LiDAR Quality Assurance (QA) Report  
Louisiana LiDAR ARRA Project - Region 1  
November 15, 2011

Submitted to:  
USGS

Prepared by:  
 **Dewberry**

Figure 8 – A LiDAR ground density model showing low point density areas in red. The majority of red in the tile is water and not an error however the linear geometry of the void shown by the arrow implies that the void is legitimate. Tile 15RYN650295.

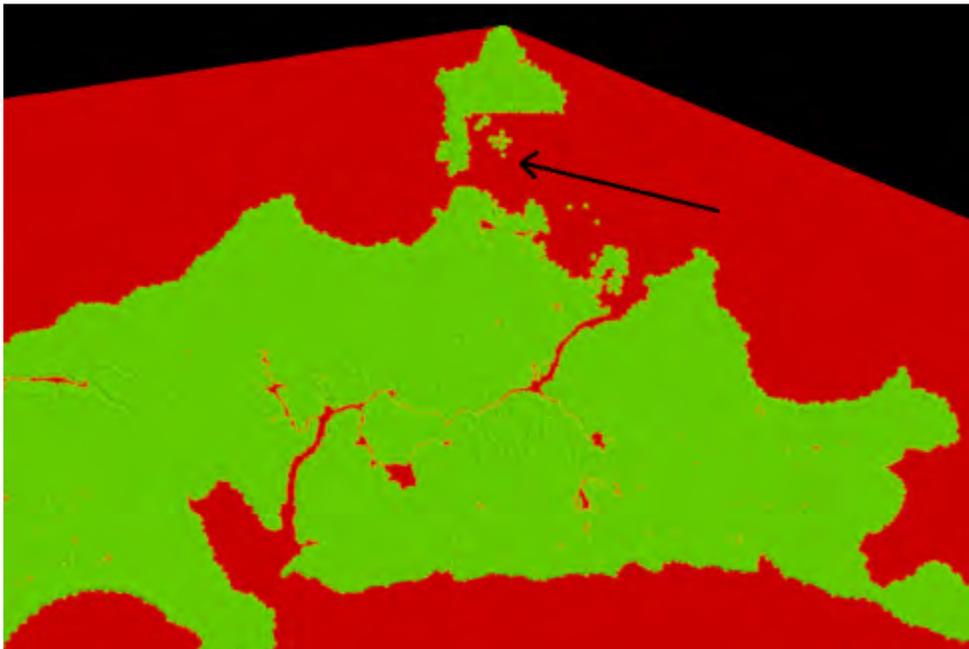
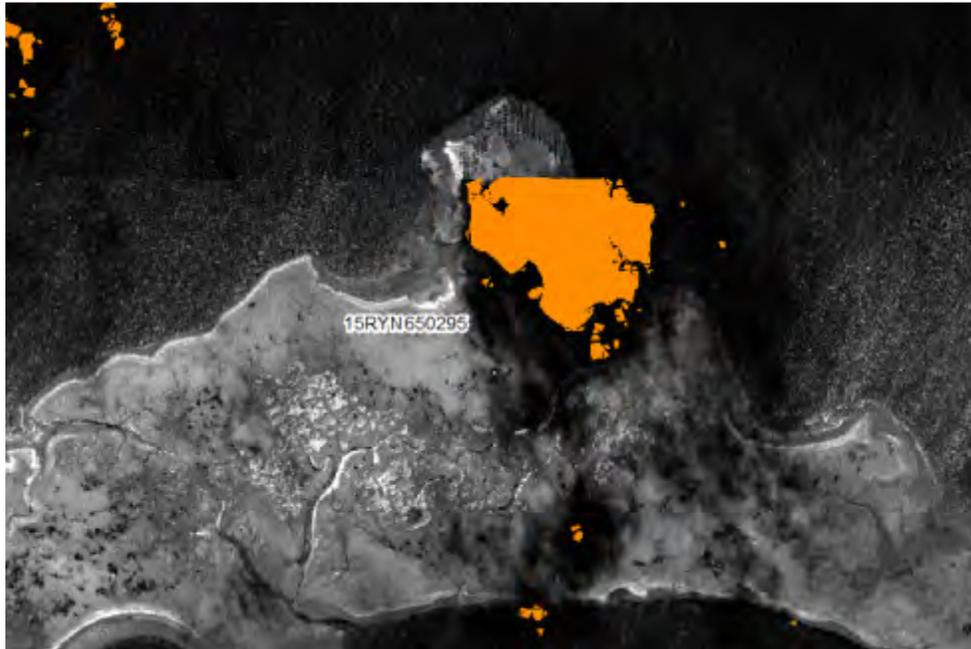
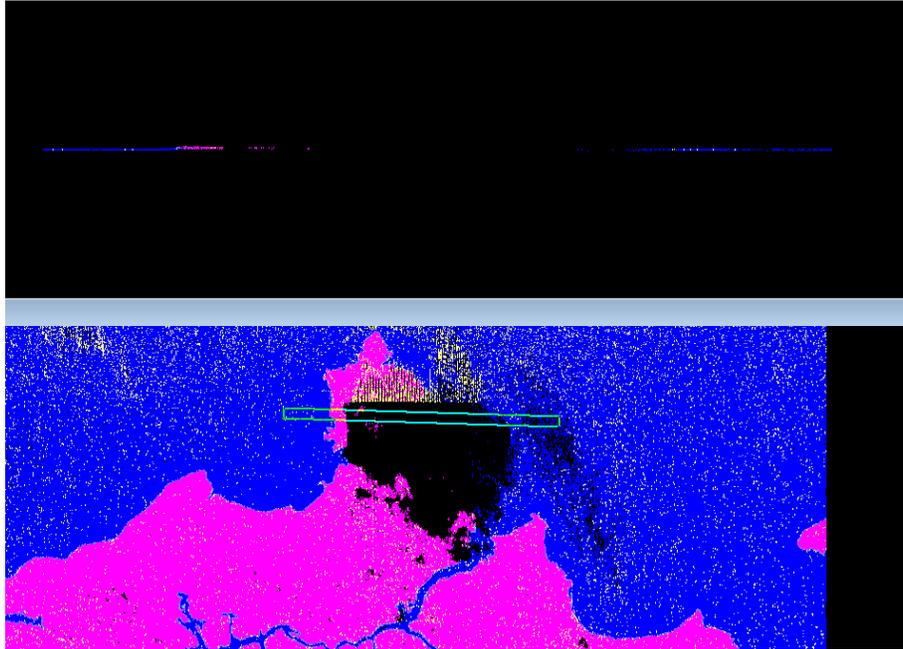
One Data void was identified in tile 15RYN650295. The void occurs in areas where the intensity values are very dark (Figure 8 to Figure 11). Because no points were collected in the void areas, they may be difficult and costly to fully correct, however users should be made aware of any data voids left in the final products. Woolpert responded to this issue and stated that “there is no available lidar coverage in this area due to excessive cloud cover.” Dewberry notes this here for the end-client.

*Figure 9 – LiDAR intensity image of the same ground feature shown in Figure 13. Voids areas where no points were collected are colored orange. The large void here intrudes on the geography in an unnatural way. The void measure approximately 5.3 acres.*

Figure 12 - Difference in ground model definition between the two tiles. The upper tile is well-defined compared to the tile below.

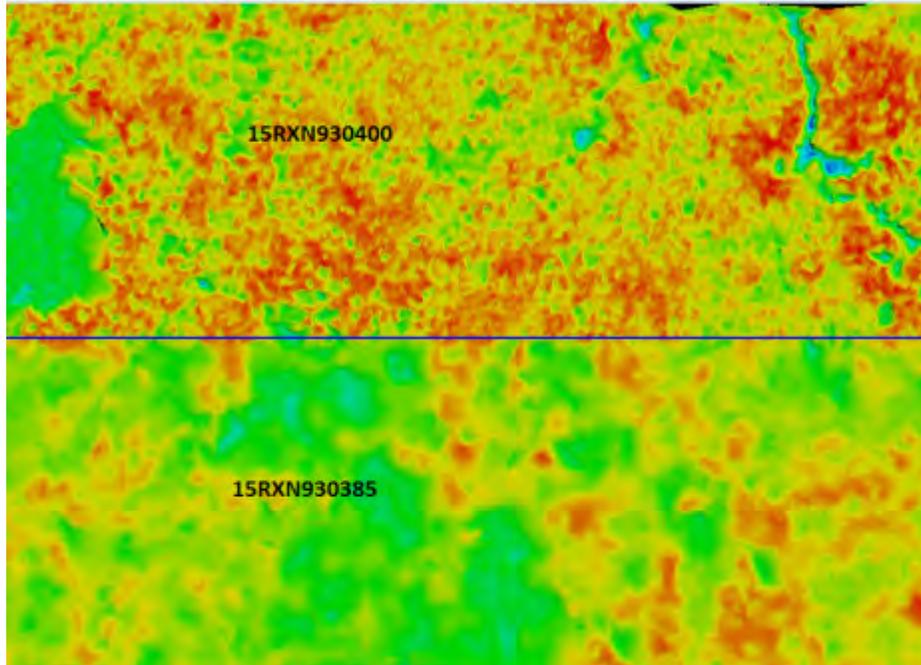
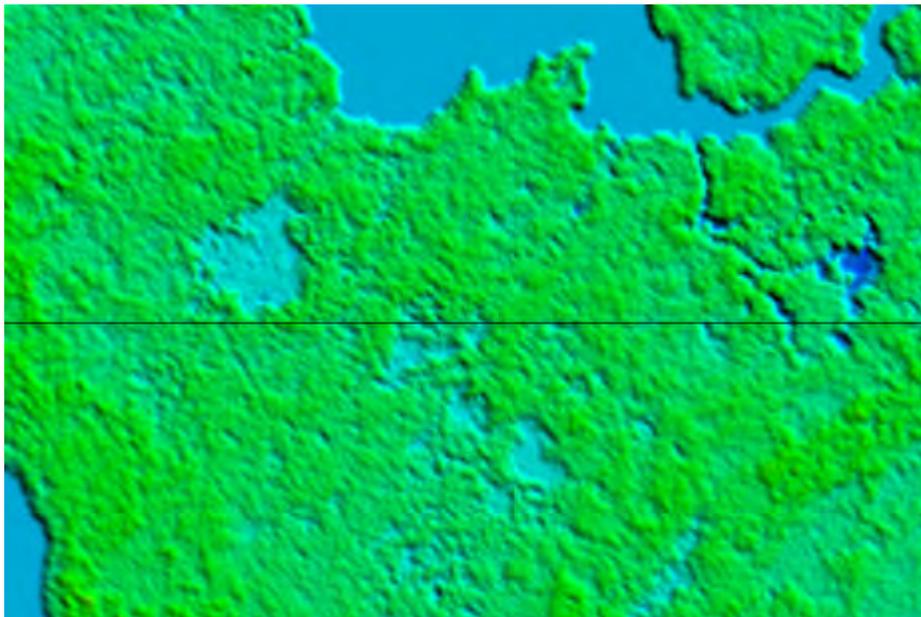
Areas in the dataset were identified where a loss of ground definition occurs. This sometime occurs across tile edges, but also seems to happen at the transition of flight line overlaps. The loss of definition to the ground does affect the ground model and Woolpert should address these areas to make a more consistent ground model. The images below use tiles 15RXN930400 and 15RXN930385 as examples. Tile 15RXN930400 has a well-defined ground and 32% of the points in the tile are classified to ground. Tile 15RXN930385 has a poorly-defined ground and only 12% if the points in the tile are classified to ground. Woolpert addressed 60 of the 64 edit calls that Dewberry made for this issue.

Figure 13 – Tiles 15RXN930400 and 15RXN930385, second delivery. Ground points have been added to the ground model which improves the overall quality of the ground model.

Figure 14 – Green dots show tiles that Dewberry recommends Woolpert deliver to ensure there is no ground.

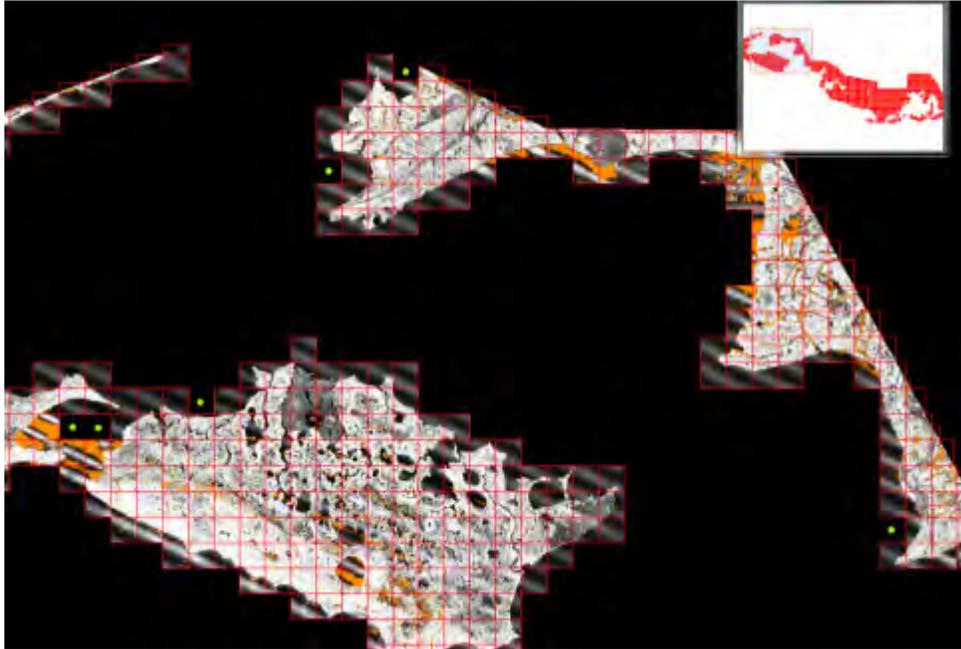
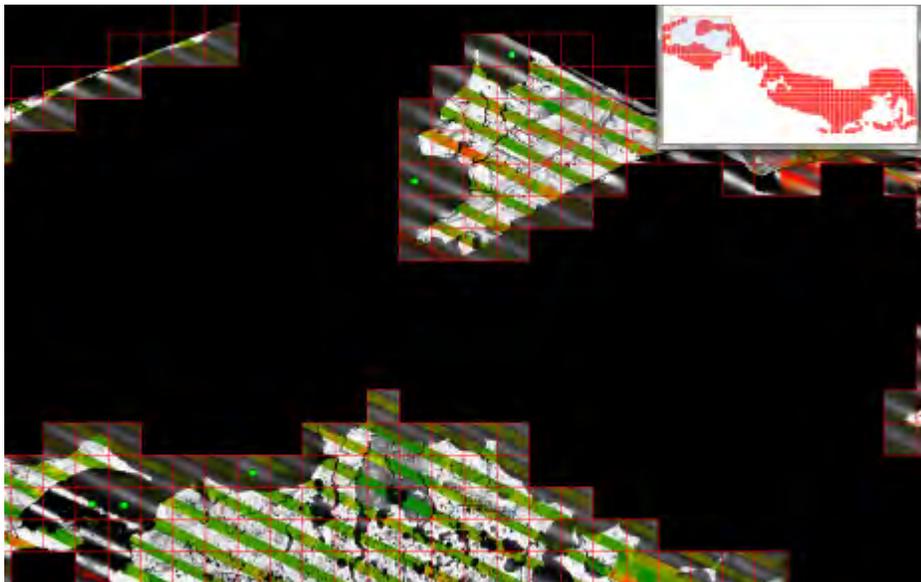
The data delivered to Dewberry appears to be missing 47 tiles. Dewberry assumes all these tiles were not delivered because they contain no ground (i.e. are entirely water). Woolpert sent these tiles in the second delivery and Dewberry confirms that these tiles do not contain ground that is misclassified.

Figure 15 – The image above confirms that the missing tiles were delivered in the second delivery.

*Figure 17 - DeltaZ image from project area, first delivery. Red and yellow areas represent places where the flight line overlap difference is greater than 10cm and is therefore out of project specifications.*

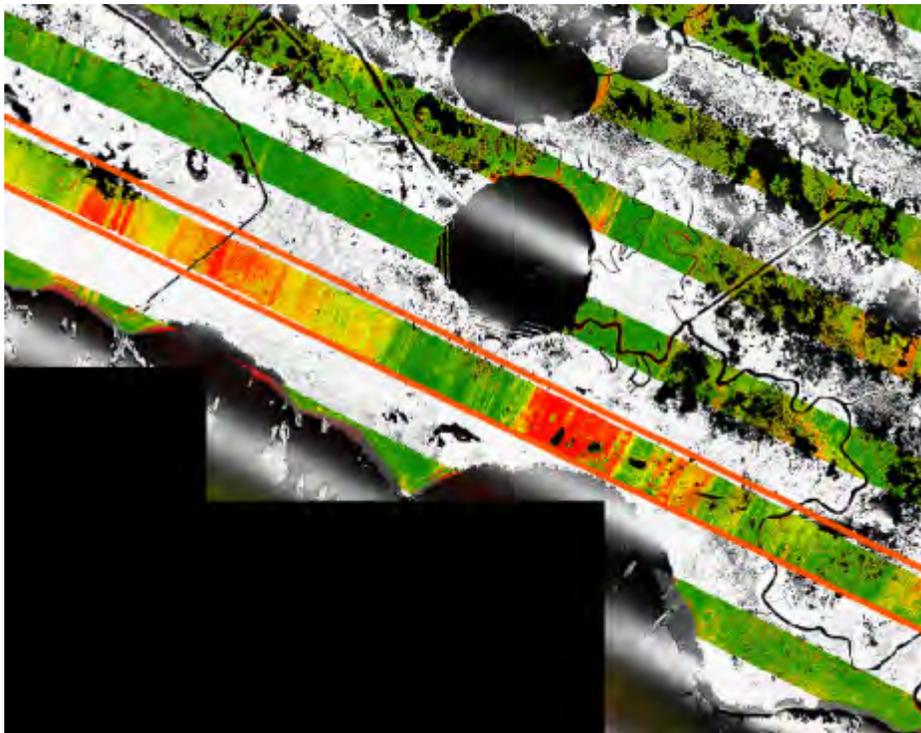
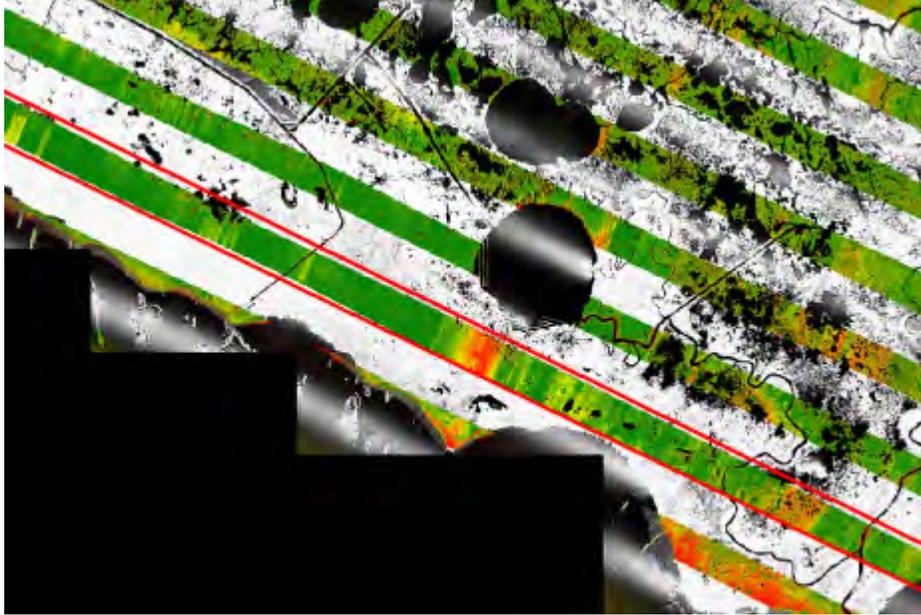
In the first delivery, several flight line ridges were identified in the Louisiana Region 1 LiDAR dataset. The ridges are caused by a vertical mismatch between two adjacent flight lines. Elevation differences along adjoining flight lines range from 10 cm up to 50 cm. Dewberry identified 100 distinct areas where a flight line ridge occurs, but after reviewing the DeltaZs, Dewberry recommended that 17 flight lines be reviewed by Woolpert for calibration issues. Woolpert addressed the majority of these issues in the second delivery. While some instances of flight line ridges occur in the dataset, Dewberry believes that

Figure 18 - DeltaZ image from project area, second delivery. Woolpert greatly reduced the flight line overlap in the dataset in the second delivery.

Figure 20 - Island breaklines are colored transparent green, Tidal water breaklines are transparent blue. The LiDAR intensity image is visible underneath the breaklines. The large land mass has now been correctly added to the island breaklines dataset.

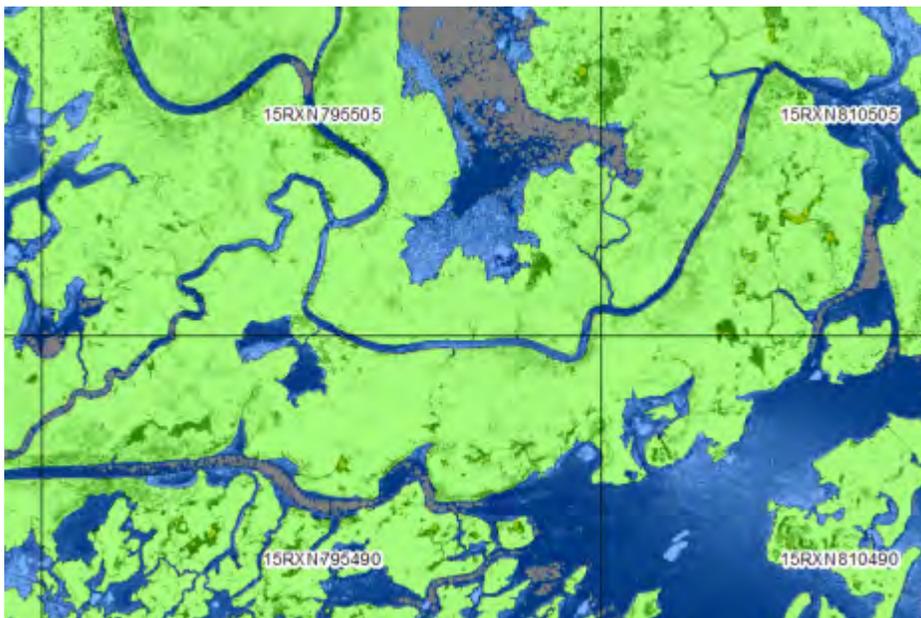
One large island was not captured as ground by the island breaklines. The island is approximately 250 acres. Woolpert corrected this issue in the second delivery. An example of the issue and its correction can be seen below in Figure 19 and Figure 20. No further issues remain with this call in the second delivery.

Figure 19 - Island breaklines are colored transparent green, Tidal water breaklines are transparent blue. The LiDAR intensity image is visible underneath the breaklines. A large land mass measuring approximately 250 square acres was not captured by the island breaklines. The island exists above the zero-elevation contour line.

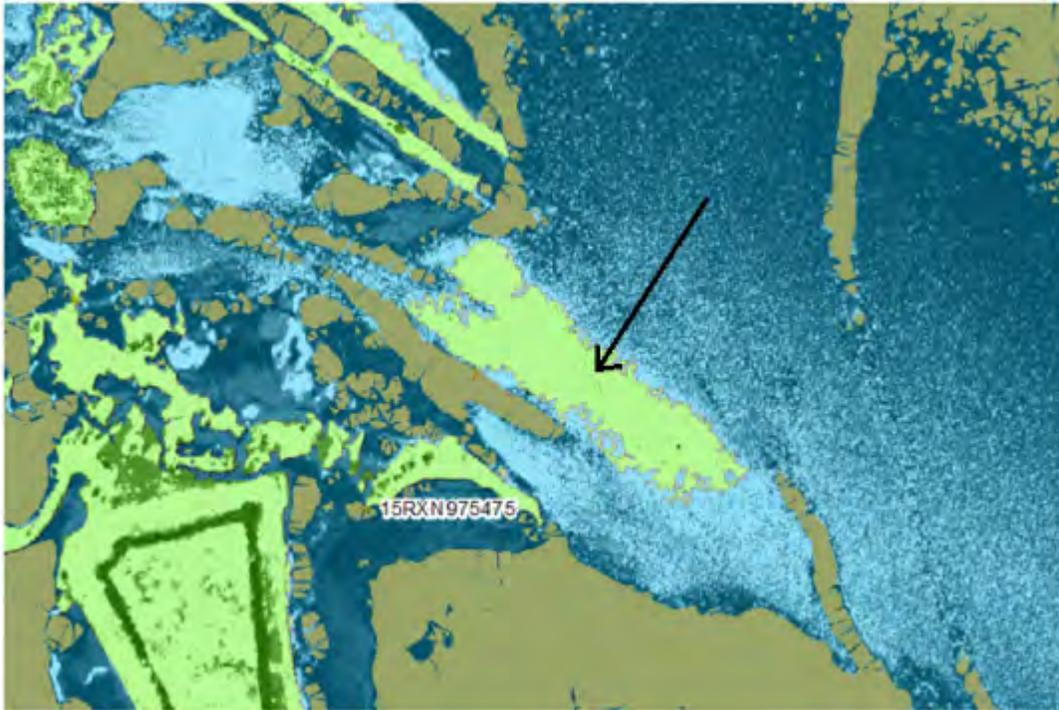
*Figure 21 – Island breaklines are colored transparent green, Tidal water breaklines are transparent blue. The LiDAR intensity image is visible underneath the breaklines. Voids in the intensity image which represent water display in tan. A large portion of water has been mistakenly captured within an island breakline.*

Figure 22 - Island breaklines are colored transparent green, Tidal water breaklines are transparent blue. The LiDAR intensity image is visible underneath the breaklines. Voids in the intensity image which represent water display in tan. The tidal water breaklines has been correctly adjusted to remove the issue.

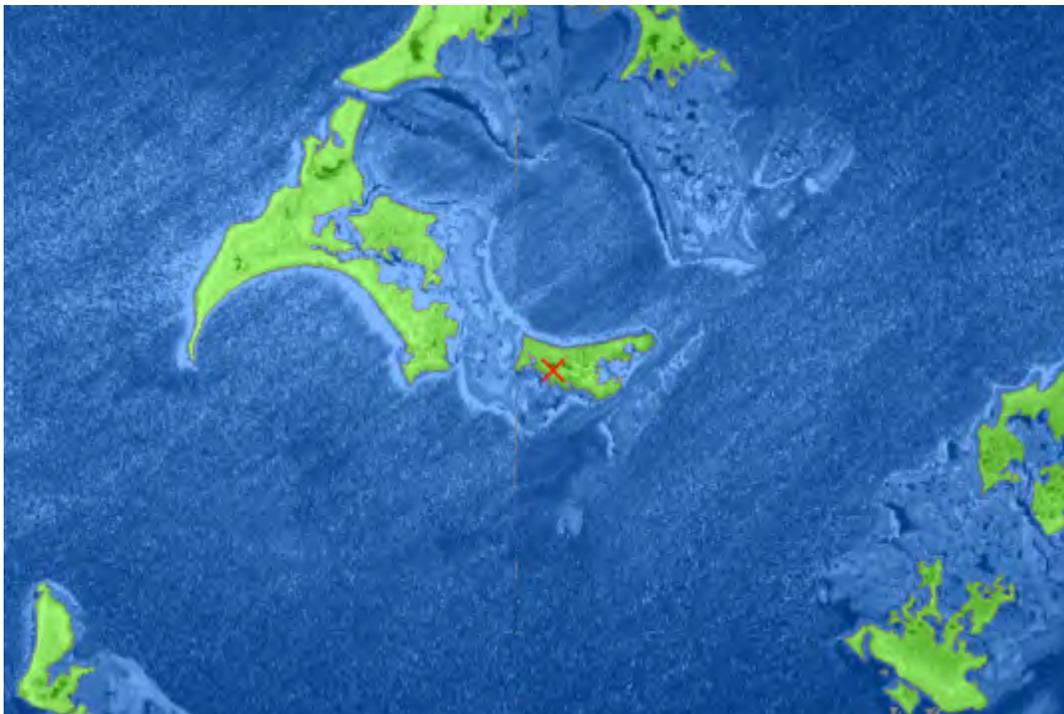
Figure 25- Tile 15RYN11265, first delivery. Island breaklines are colored transparent green, Tidal water breaklines are transparent blue. The LiDAR intensity image is visible underneath the breaklines. The image above shows ground that was captured as part of the tidal water breaklines.

Figure 26- Figure 27- Tile 15RYN11265, third delivery. Island breaklines are colored transparent green, Tidal water breaklines are transparent blue. The LiDAR intensity image is visible underneath the breaklines. The image above shows that the ground was appropriately changed to the island breakline feature class.

Figure 32 – Tile RYN050475, second delivery. The above image shows an example of the remaining floating water in the DEM. Dewberry recommends that no further fixes are required in these areas.

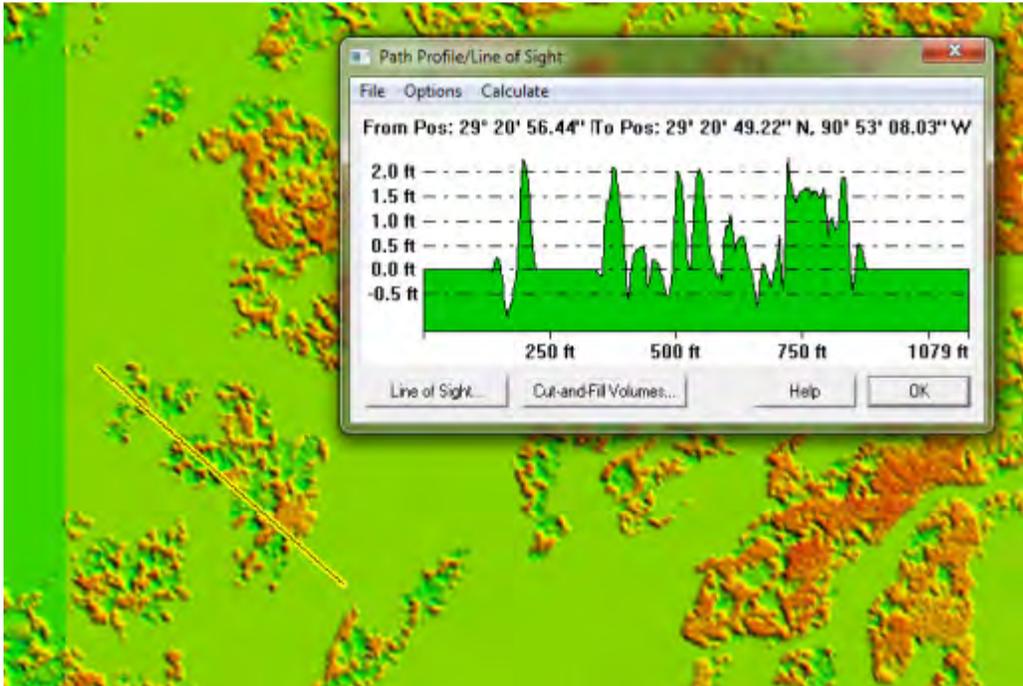
Several vertices were discovered that float above the terrain surface. In the first delivery Dewberry reviewed and identified 19 water features that significantly float above or dig below the water. Of these 19 issues Dewberry identified 11 that were not corrected in the second delivery of the breaklines. These features have a direct impact on the DEM. These issues may be caused by the predetermined "0" elevation for water body features. The land around these breaklines is lower than 0 meters causing raised water bodies in the area.

Dewberry discussed this issue with the USGS and because of the method used to collect breaklines it was determined that these floating areas would be acceptable in this delivery. The images below are provided to make the end-user aware of the issue.
